SUBJECT: Storm Drainage Of Miano Gutierrez Lower Add.

OFIMIANO GUTIERREZ LOWER ADDITION

TITLE: STORM DRAINAGE IN OFIMIANO GUTIERREZ LOWER ADDITION

DRAWING NO. W-29-134 SHEET OF

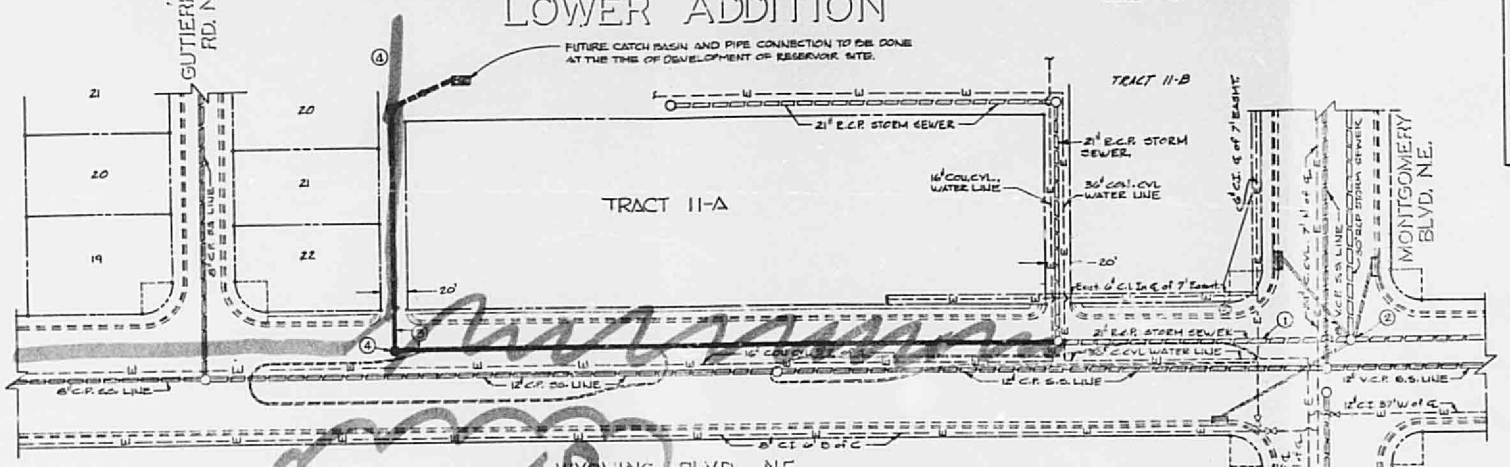
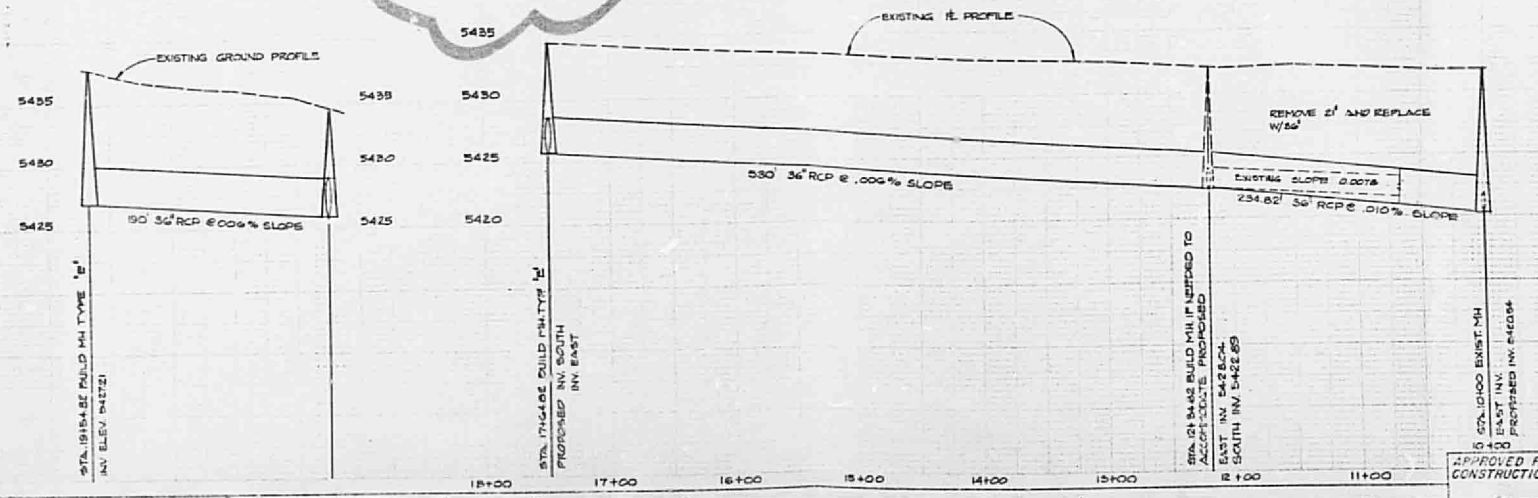
Request review and comments on attached drawings. Typed comments will be submitted to Celia, by 11/12/80.

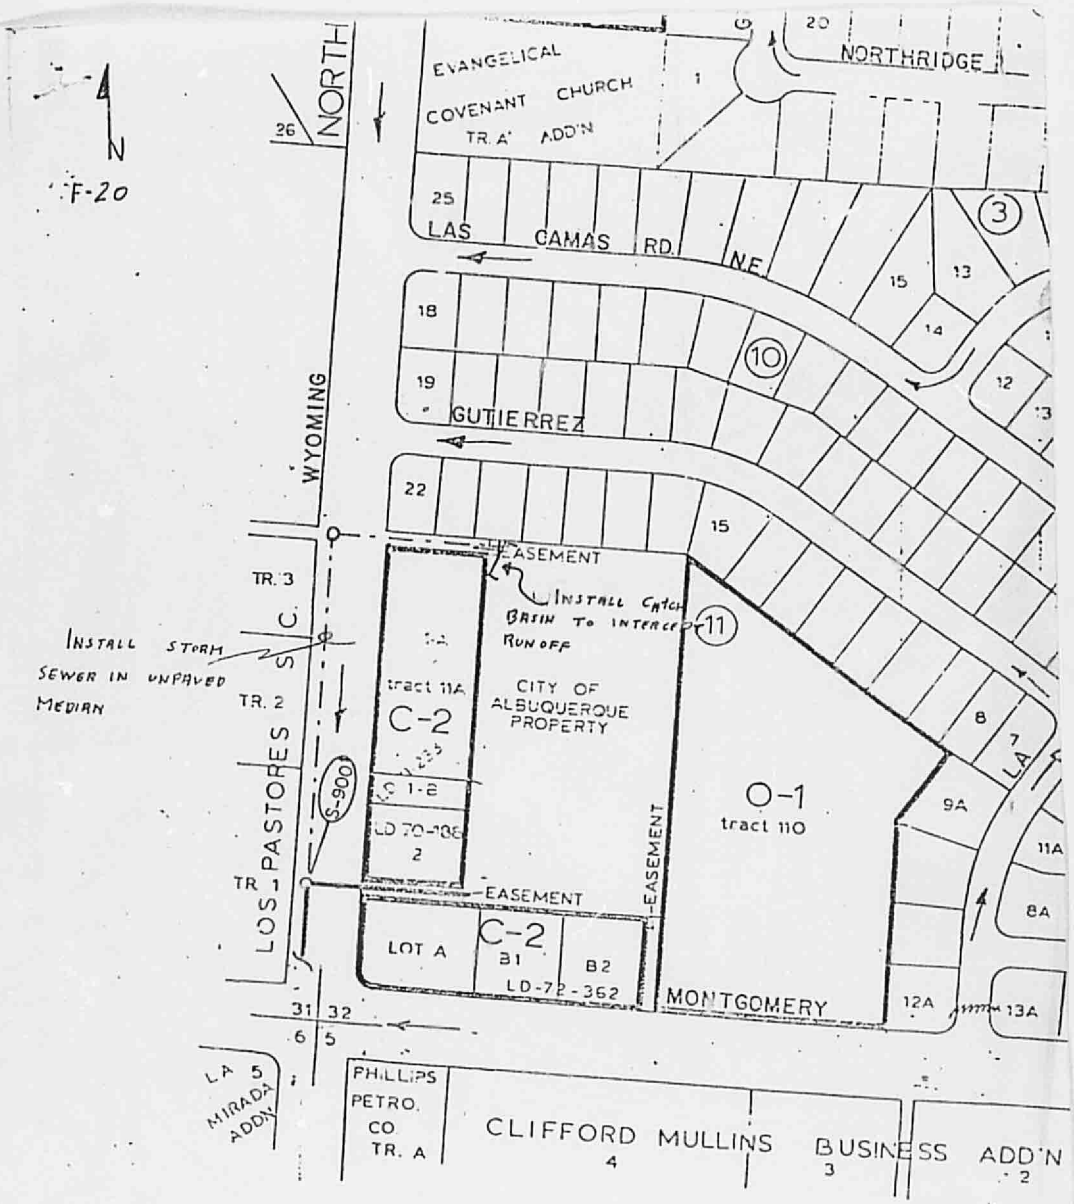
Due to the proposed development of Tract 11A, Lower Terrace (O.G.) Addition, it is necessary to provide a method of handling the storm runoff discharge from the Thomas Reservoir site. It is requested that a design and estimate be prepared for a storm sewer extension as indicated on the attached sketch. In addition to the runoff capacity requirement, which shall be determined by the Hydrology Engineer, the sewer shall have capacity for 29.2 MGD for future use as the wash line of a 2nd reservoir on the site. Account number 011071-527500 shall be used for payment.
